# Technical Bulletin

Model(s)	Year	Eng. Code	Trans. Code	VIN Range From	VIN Range To
Passat	2014-2015	All	All	A3_EC000000	A3_FC054650

70 15 01 April 10, 2015 2040091

### Instrument Panel Creaking Noise

Figure 2

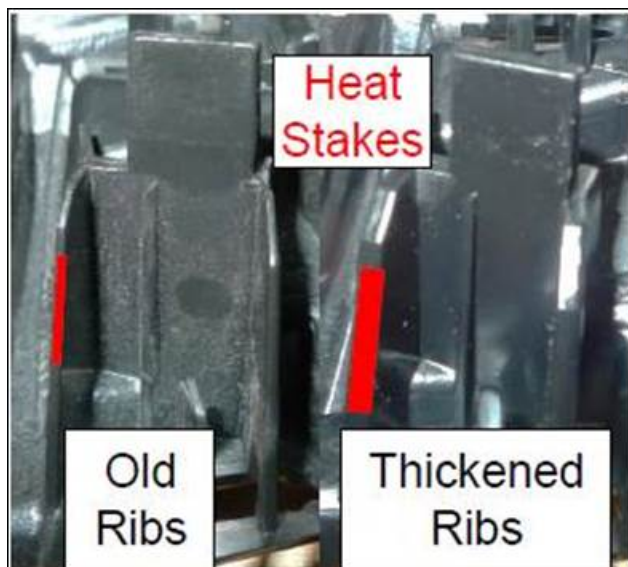
Strengthened rib around the Heat stake to prevent damage (figure 2).
